Product Safety Warning - Updated Information

Total Solutions & Power (TSP) accumulators

SL2016-616/PRP
May 2016

Product safety warning letter concerning accumulators produced by TSP.

Fig. 1: TSP accumulator

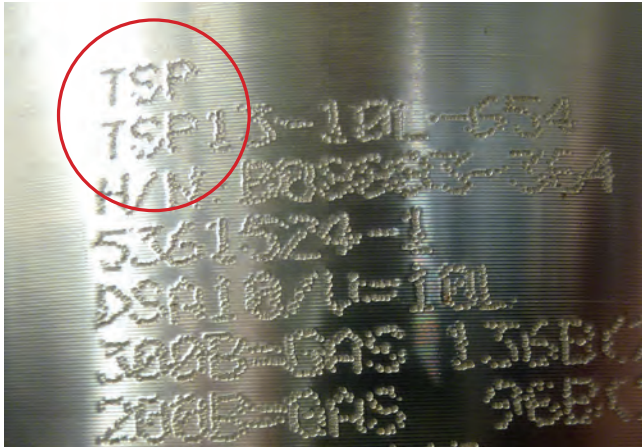
We wish to clarify that only accumulators of the TSP 10L design are affected. Furthermore, the affected accumulators are restricted to the accumulators fitted to the hydraulic system on ME engines of our design with 300-bar working pressure. Accordingly, accumulators fitted to the Alpha Lubricator system and to the MC-type engines are not affected.

The TSP accumulator can be identified as shown in Fig. 1.

Fig. 2: 10L accumulators produced in 2013

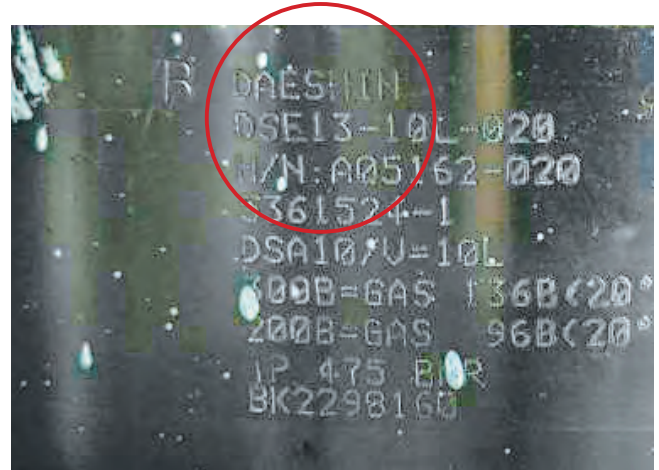
TSP produced 10L accumulators in 2013 which are marked Daeshin, see Fig. 2. These must also be exchanged.
